UNITED STATES PATENT AND TRADEMARK OFFICE

APPLICATION NO.	FILING DATE	FIRST NAMED INVENTOR	ATTORNEY DOCKET NO.	CONFIRMATION NO.
09/367,153	08/09/1999	ALASTAIR SIBBALD	62-194	3951

Office Action Summary

DETAILED ACTION***Claim Objections***

Fig.8.

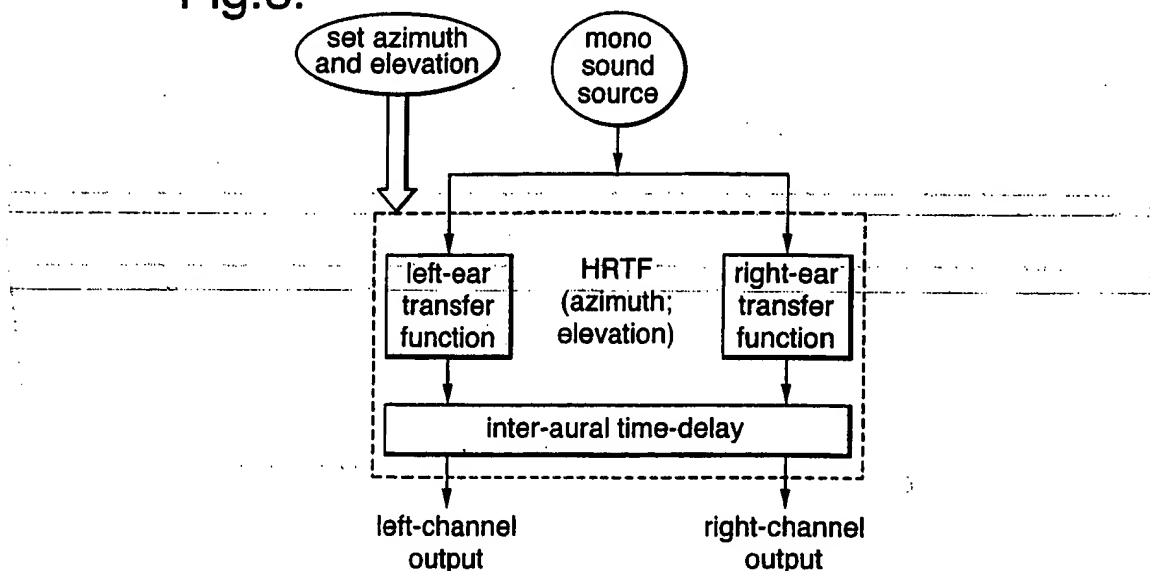
3. Claims 14 is rejected under 35 U.S.C. 103(a) as being unpatentable over applicant's admitted prior art (page 2, line 23; Figure 8).

Regarding claim 14, the applicant's admitted prior art discloses a prior art method of processing an audio signal.

It teaches of left and right channel output signals created from a mono sound source, which reads on “providing a right channel and left channel, each of said right channel and left channel carrying said single channel audio signal”; both the left and right channel processed using HRTF on each channel separately which reads on “modifying said single channel audio signal of each of said right channel and said left channel using at least one of a plurality of head response transfer functions to provide a right signal in said right channel for a right ear of said listener and a left signal in said left channel for a left ear of said listener”; both the right and left signals are delayed which reads on “introducing a time delay between said right channel and said left channel to provide cues to perception of a direction of said source position relative to said preferred position of said listener at a given time, and said time delay corresponding to an interaural time difference of said sound from sound source with respect to said listener”. The interaural time difference describes the time delay between sounds arriving at the left and right ears. It is well known in the art that interaural time difference is a source of localization cues. It is obvious that you would use the respective values of magnitude of the left and right signal to provide cues for perception of the source position from the preferred position at said given time because the goal is to achieve the best possible and most accurate sound. Thus it would have been obvious to one of ordinary skill at the time of the invention to use the applicant’s prior art in order to process a single channel audio signal using binaural processing in order to achieve the best sound.

4. Claim 44 is rejected under 35 U.S.C. 103(a) as being unpatentable over applicant’s admitted prior art (Figure 8).

Regarding claim 44, the applicant's admitted prior art discloses a prior art method of processing an audio signal. It teaches of a mono sound source which reads on "an audio signal"; left and right channel output signals created from that mono sound source and both the left and right channel processed using HRTF on each channel separately which reads on "a right signal for a right ear of a listener, said right signal being obtained by modifying a single channel audio signal using at least one of a plurality of head response transfer functions, said single channel audio signal corresponding to a sound from a sound source located at a source position relative to a preferred position of said listener" and also reads on "a left signal for a left ear of said listener, said left signal being obtained by modifying said single channel audio signal using at least one of a plurality of head response transfer functions"; both the right and left signals are delayed which reads on "wherein said left signal and said right signal having there between a time delay to provide cues to perception of a direction of said source position relative to preferred position of said listener at a given time, said time delay corresponding to an interaural time difference of said sound from said sound source with respect to said listener". The interaural time difference describes the time delay between sounds arriving at the left and right ears. It is well known in the art that inter-aural time difference is a source of localization cues. It is obvious that you would use the respective values of magnitude of the left and right signal to provide cues for perception of the source position from the preferred position at said given time because the goal is to achieve the best possible and most accurate sound. Thus it would have been obvious to one of ordinary skill at the time of the invention to use the applicant's prior art in order to have an audio signal comprising the claimed matter for the benefit of achieving the best sound for the listener.
